RESOLUTION OF THE TOWN OF ST. LEO TOWN COMMISSION
APPROVING SAINT LEO UNIVERSITY INC. SOCCER/LACROSSE FIELDS AND
PARKING GARAGE SITE PLAN/VARIANCE REVIEW-SPR/VAR #11-F-
MODIFICATION #2 WITH CONDITIONS.

SITE PLAN (SPR)/VARIANCE (VAR) REVIEW STAFF REPORT
SPR/VAR#11-F-MODIFICATION #2
Saint Leo University Soccer/Lacrosse Fields and Parking Garage
Town Commission Meeting February 13, 2012

Request: Approve a second modification to a previously approved site plan for the Soccer/Lacrosse Fields and Parking Garage project with wetland/forested area and wetland/forested area buffer variances

ATTACHMENT 1
SITE PLAN

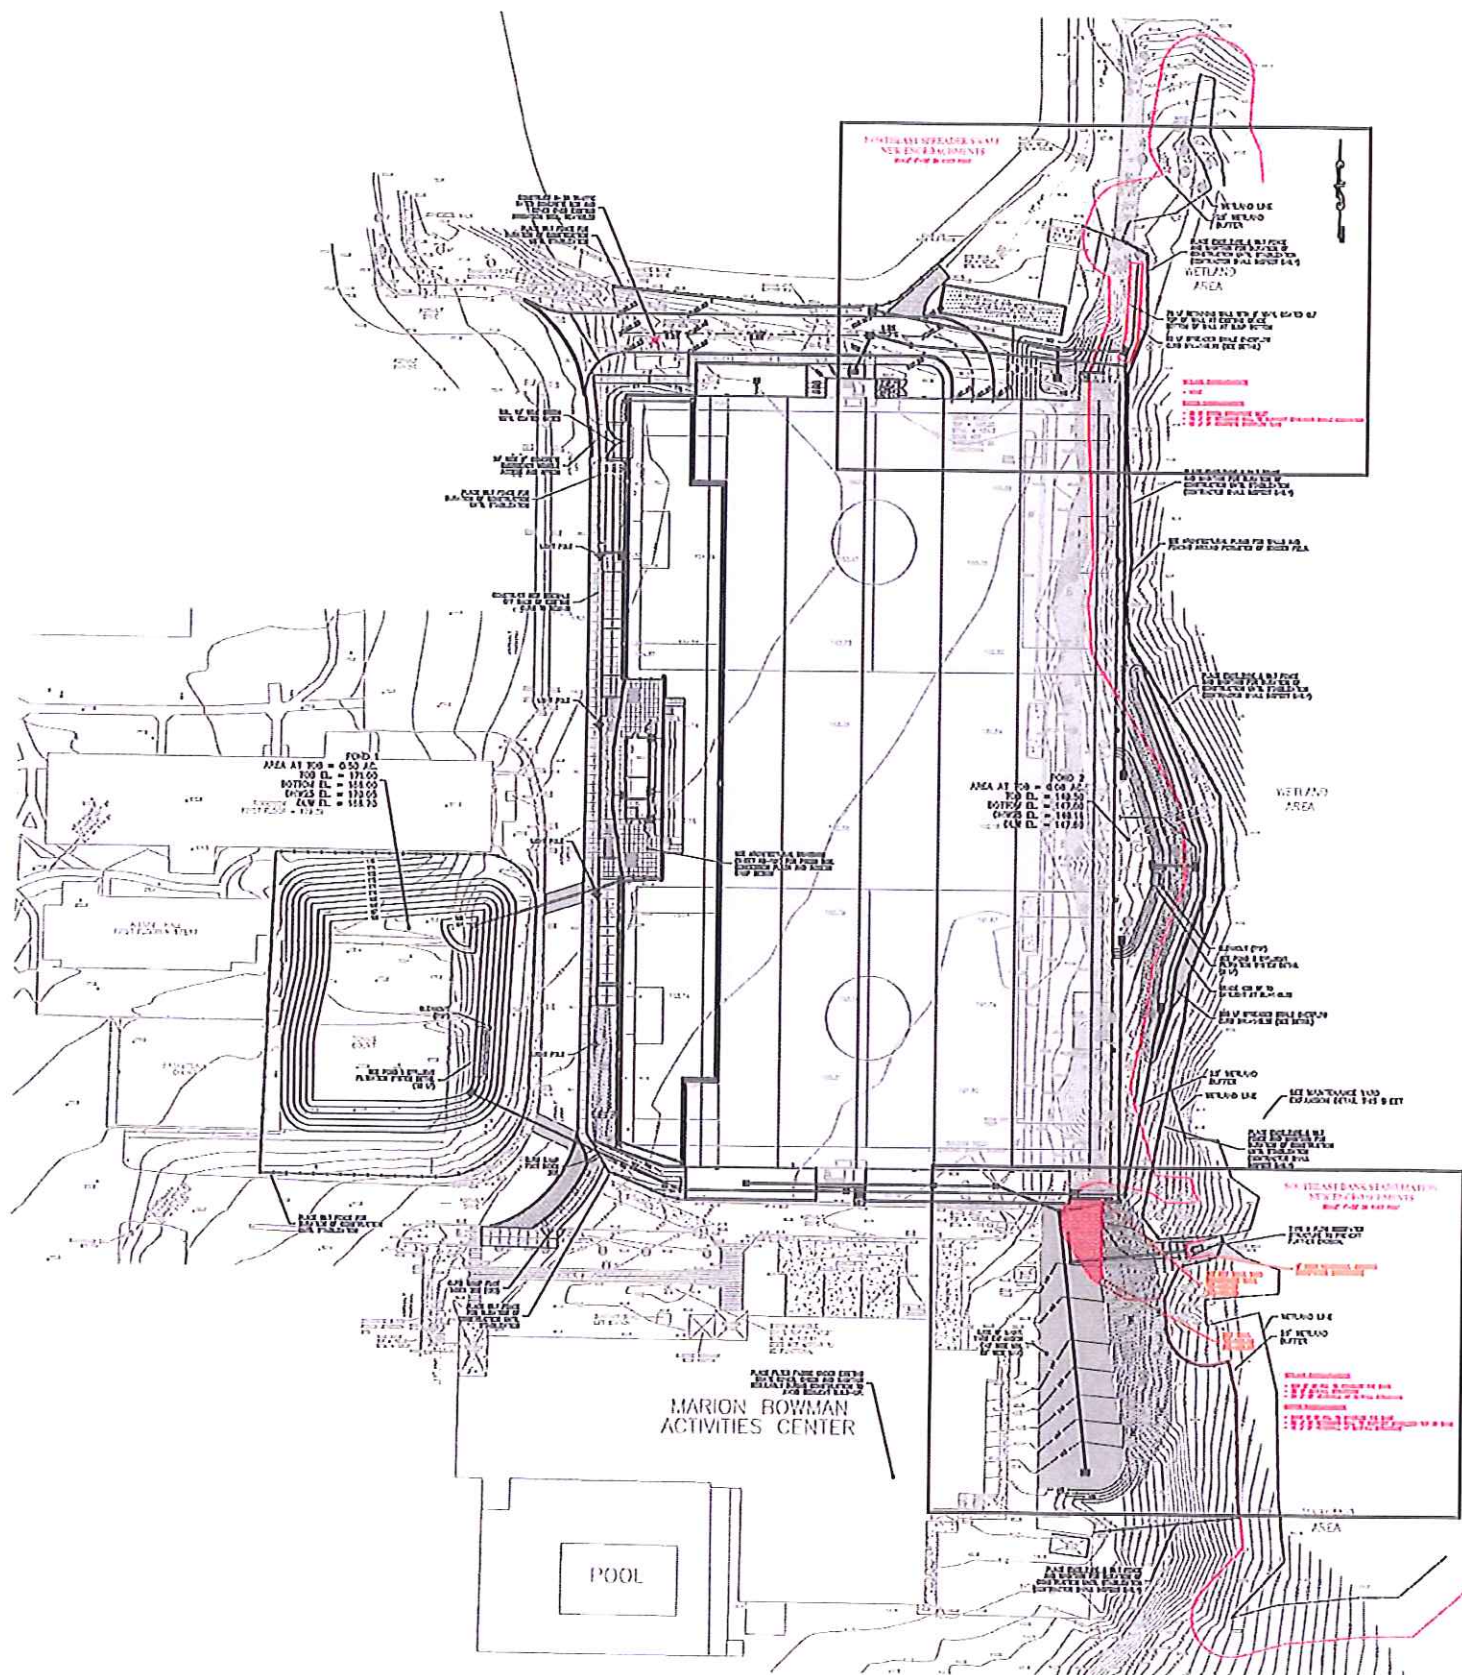
For ease of reference, Appendix A contains selected Applicant drawings and documents referenced in this report and Appendix B contains the Applicant's entire submittal. The current application (Modification #2) results from erosion issues that surfaced during construction that occurred at the northeast and southeast corners of the parking garage (Appendix A, Attachment #1). It is noted that a stop work order was issued on January 12, 2012 when these issues arose related to wetland impacts and tree removal. As a result of these issues, and direction from SWFWMD to address the problem, the following are proposed:

ATTACHMENT 4
SE BANK STABILIZATION

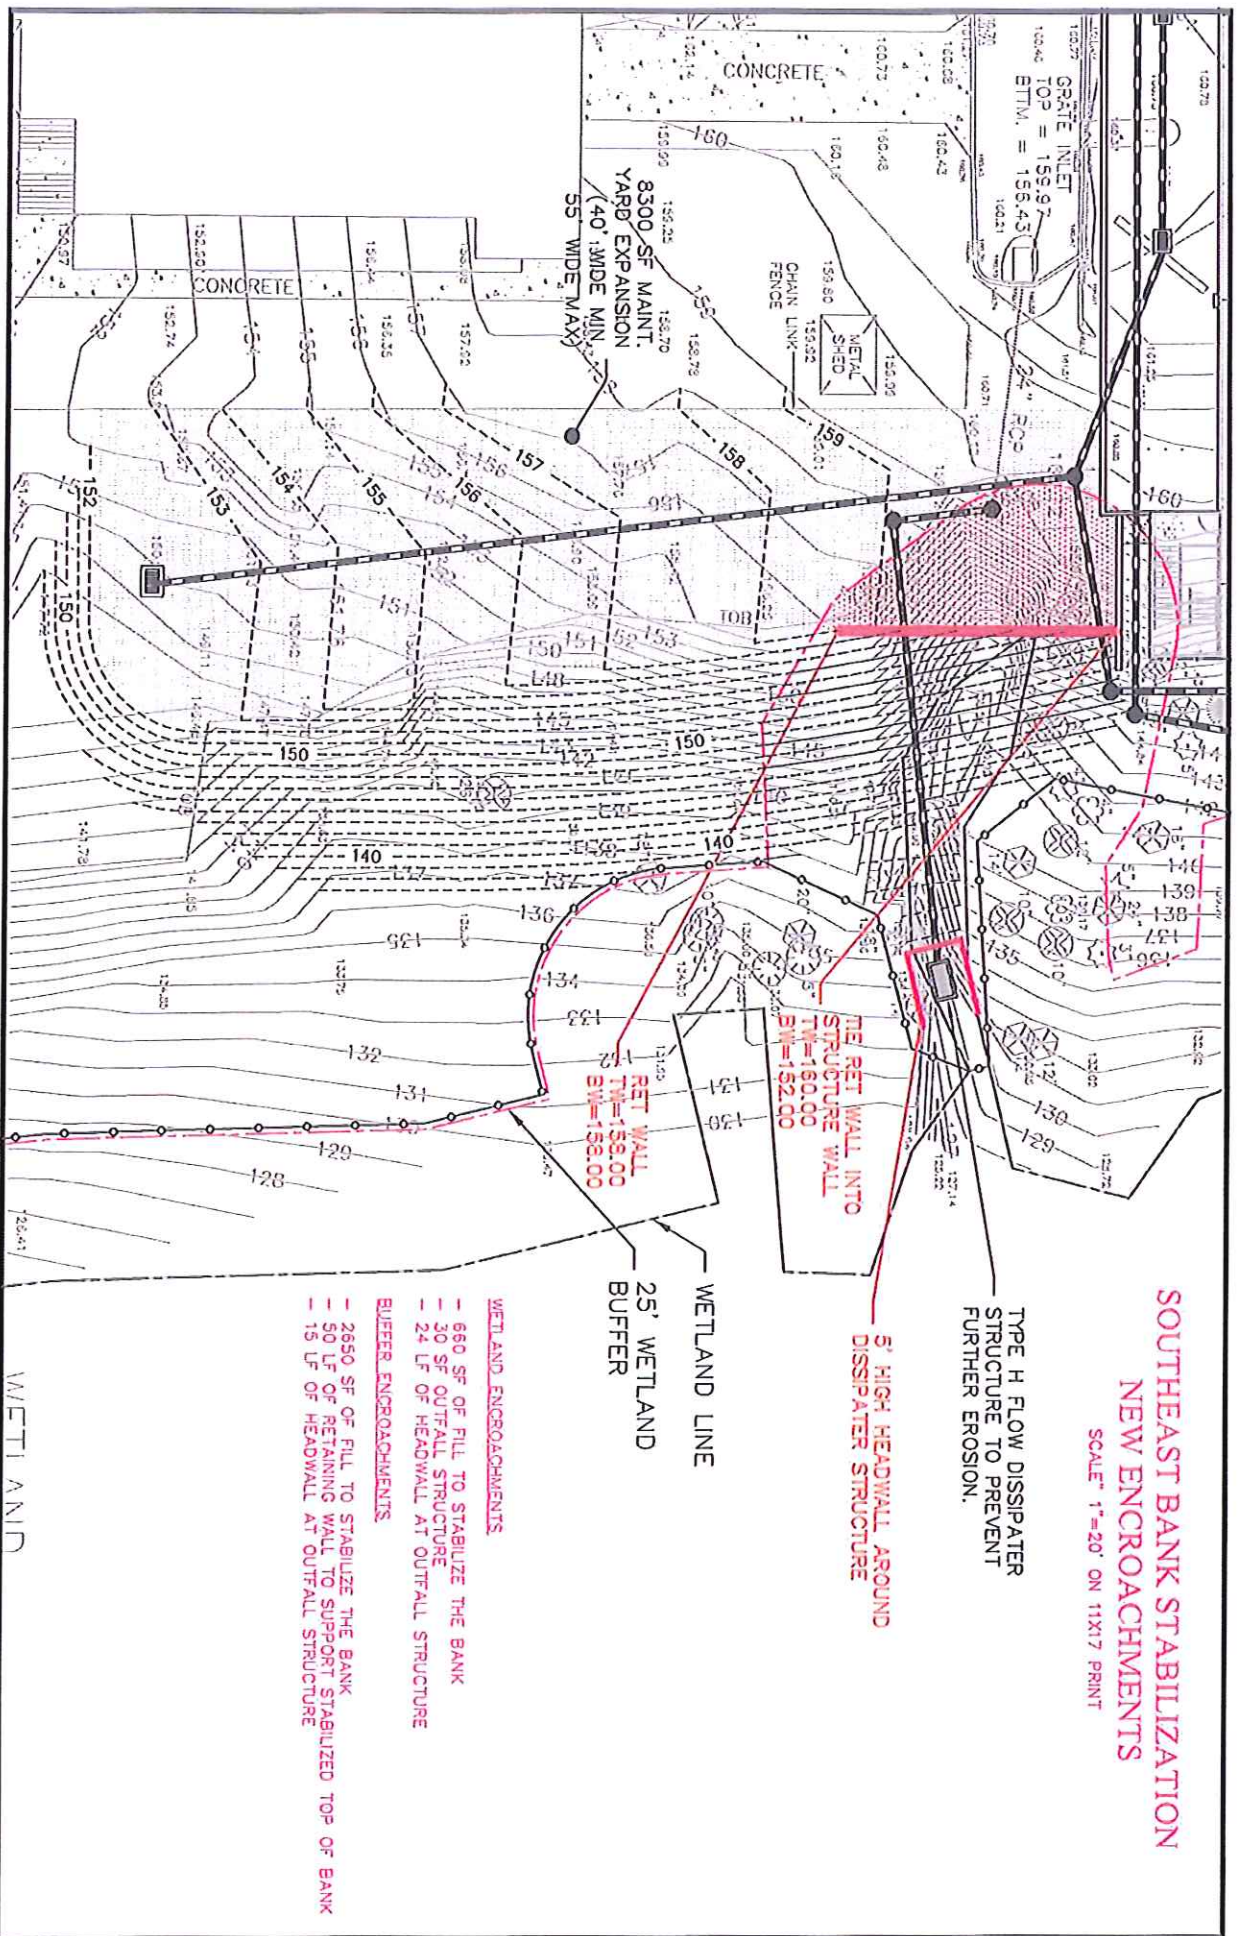
1. A 50 linear foot retaining wall is required at the southeast corner of the parking garage which will be located within the wetland/forested area buffer zone (Appendix A, Attachment 4). The wall and associated grading will result in the loss of two protected trees (see Tree Removal application). In addition, a flow dissipater structure and associated headwall will be located within the wetland. This will impact an approximate 714 square foot wetland area.
2. A 78 linear foot retaining wall is required at the northeast corner of the parking garage, which will be located within the wetland/forested area buffer zone (Appendix A, Attachment 6).

When construction began, the project engineer discovered the bank at the southeast corner of the project area was severely eroded and unstable. The slope was essentially being held together by a combination of construction debris, tree roots and soil. The erosion was so severe that the existing stormwater pipe that discharges into the wetland at this point is unsupported and has collapsed. The pipe collapse appears to have occurred many years ago and was not visible at the time of the original variance submission. To mitigate this problem the project engineer has developed a plan to stabilize the bank and reconstruct the stormwater pipe and outfall which in turn will return the integrity of the stormwater system (Appendix A, Attachment 4 – SE Bank Stabilization). This will include removing the unconsolidated material; reconstructing the stormwater pipe; and backfilling the slope with material that will stabilize the bank. Mitigation of this issue will require work in both the wetland buffer and the wetland itself. SWFWMD, who is requiring the bank to be stabilized and the stormwater system repaired, has given tentative approval.

ATTACHMENT 6
NE SPREADER SWALE

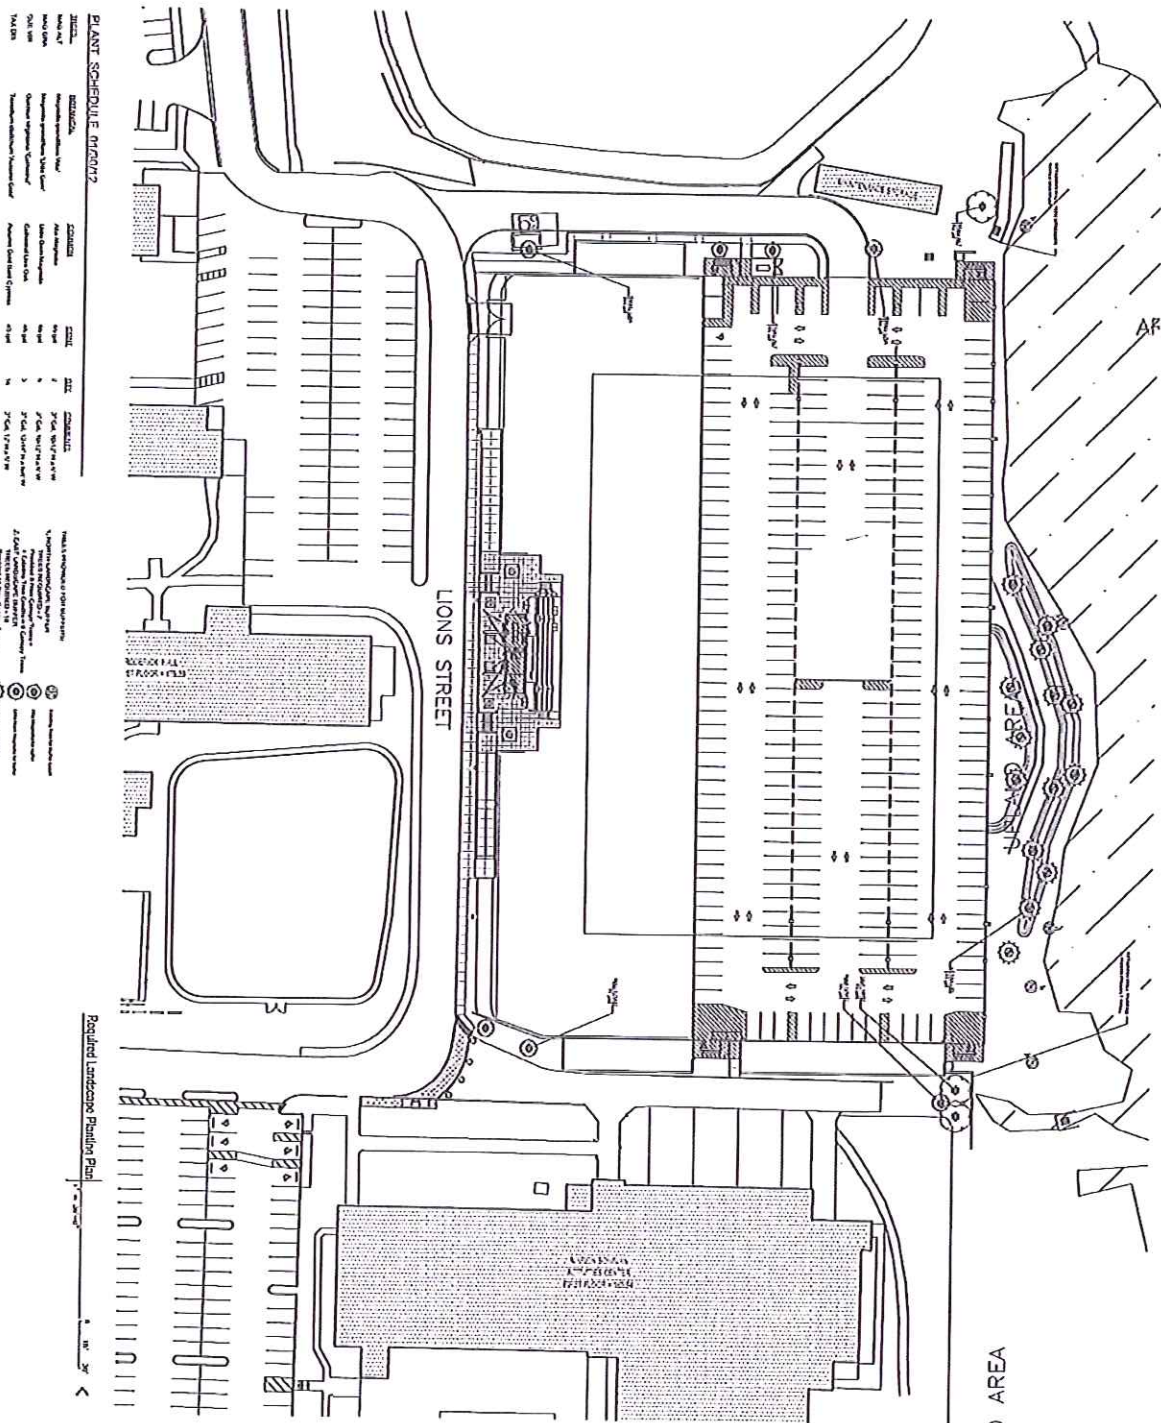
The northeast corner of the project area also requires a modification that will require the Town's consideration. The original site plan reviewed by the Town depicted a stormwater pipe discharging runoff from the northern part of the complex to the eastern wetland. The original plan proposed a "bubbler" at the end of the stormwater pipe to dissipate the energy of the stormwater flow as it exited the pipe to protect the bank from further erosion. This stormwater discharge is located at a specific point on the bank to ensure that the wetland will continue to receive adequate hydration from stormwater flows. When this design was proposed to SWFWMD within the Environmental Resource Permit (ERP) Application, the District rejected the proposed "bubbler" because of the potential for continued bank erosion. However, in lieu of the "bubbler" they suggested and subsequently permitted a spreader swale. This swale was, in their opinion, a more effective alternative to slow down the stormwater flow and better protect the bank from erosion (Appendix A, Attachment 6 – Spreader Swale).

ATTACHMENT 4
SE BANK STABILIZATION

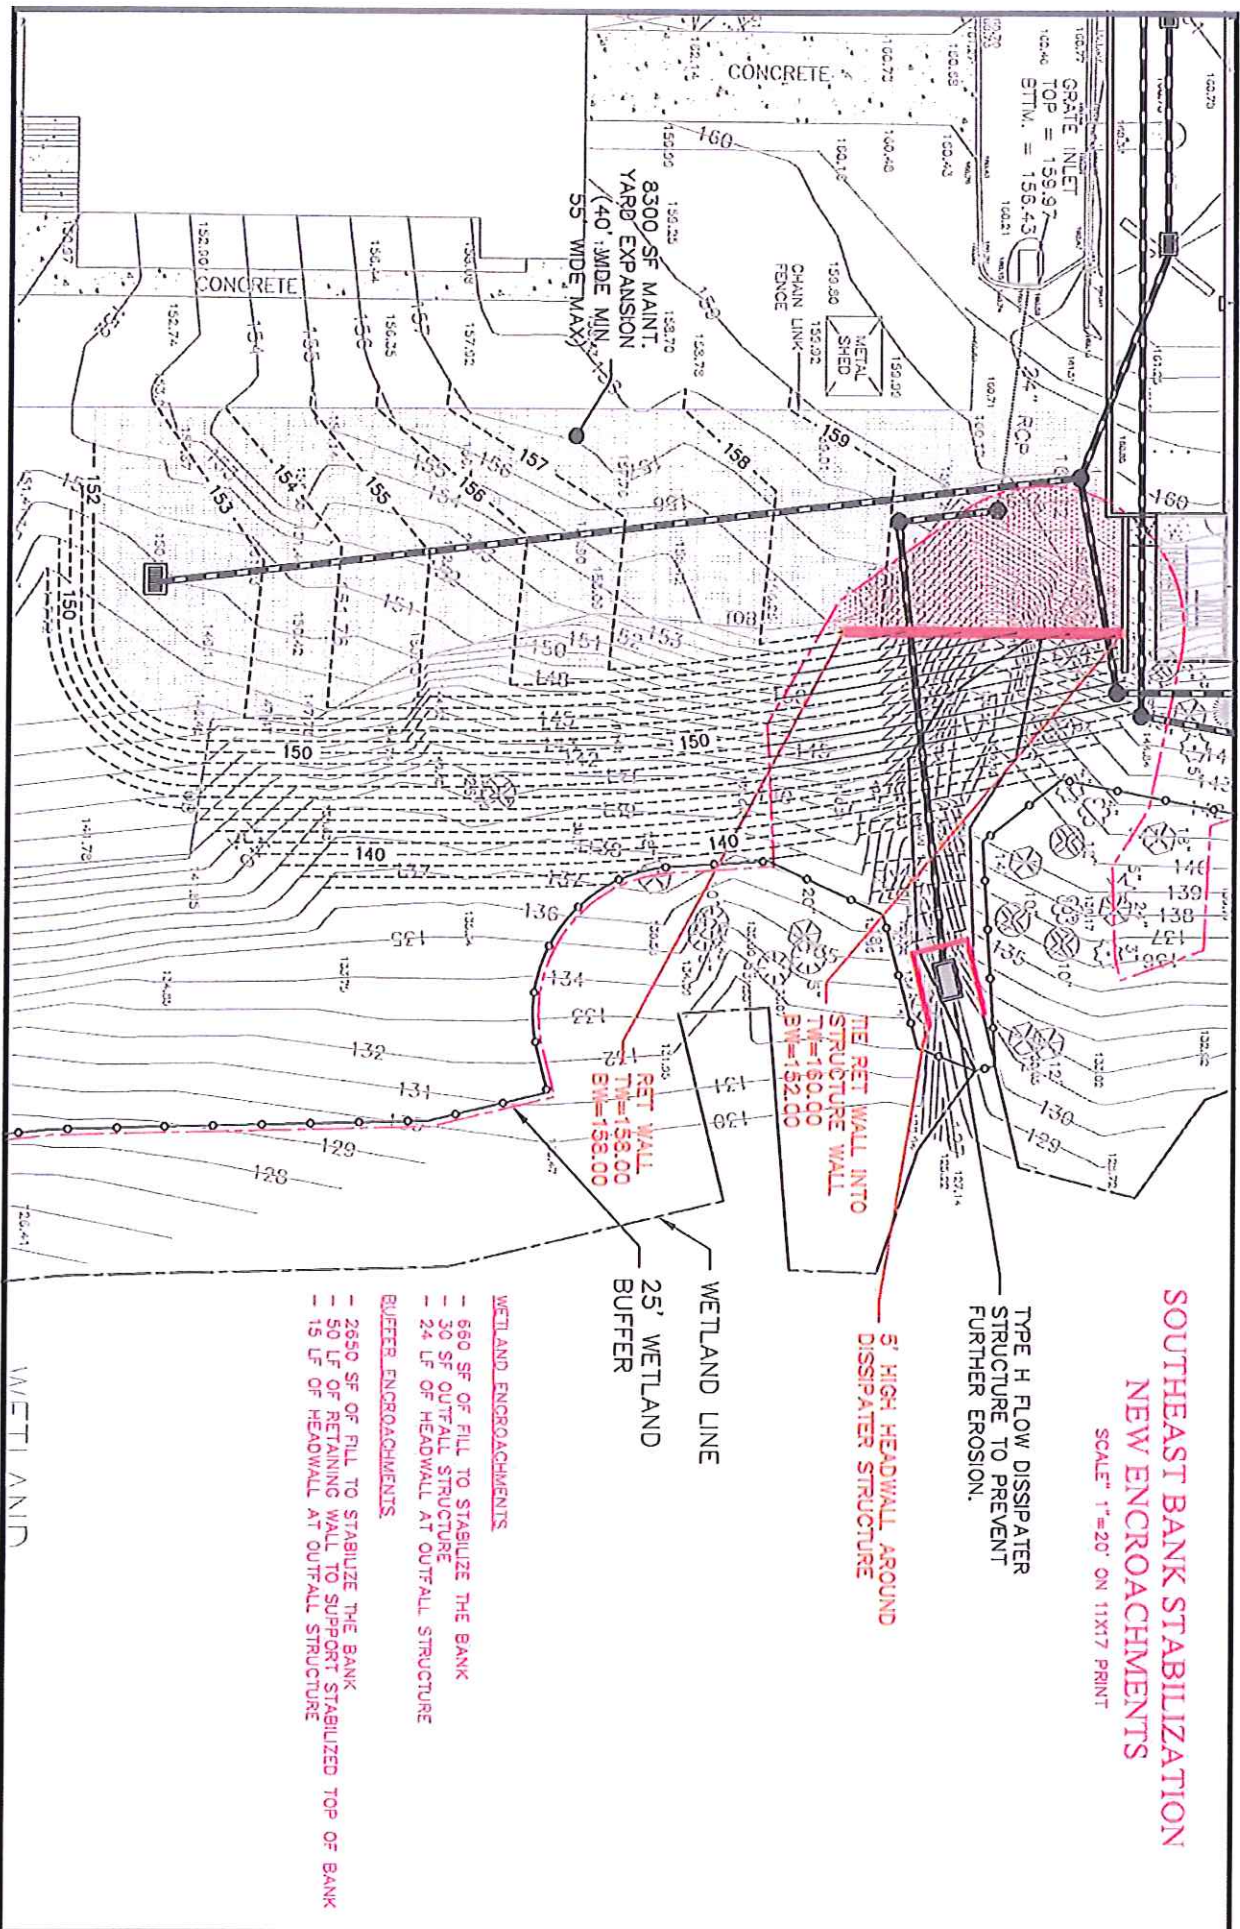
When construction began, the project engineer discovered the bank at the southeast corner of the project area was severely eroded and unstable. The slope was essentially being held together by a combination of construction debris, tree roots and soil ([Attachment 2 - Photo #1](#)). The erosion was so severe that the existing stormwater pipe that discharges into the wetland at this point is unsupported and has collapsed ([Attachment 3 - Photo #2](#)). The pipe collapse appears to have occurred many years ago and was not visible at the time of the original variance submission. To mitigate this problem, the project engineer has developed a plan to stabilize the bank and reconstruct the stormwater pipe and outfall which in turn will return the integrity of the stormwater system ([Attachment 4 – SE Bank Stabilization](#)). This will include removing the unconsolidated material, reconstructing the stormwater pipe, and backfilling the slope with material that will stabilize the bank. Mitigation of this issue will require work in both the wetland buffer and the wetland itself. SWFWMD, who is requiring the bank to be stabilized and the stormwater system repaired, has given tentative approval ([Attachment 5 – SWFWMD emails dated December 9, 2011 and January 4, 2012](#)). We have proposed a design that minimizes impacts to existing trees; however, this proposed project will require the removal of additional trees not included in the December 2011 Tree Removal Variance.
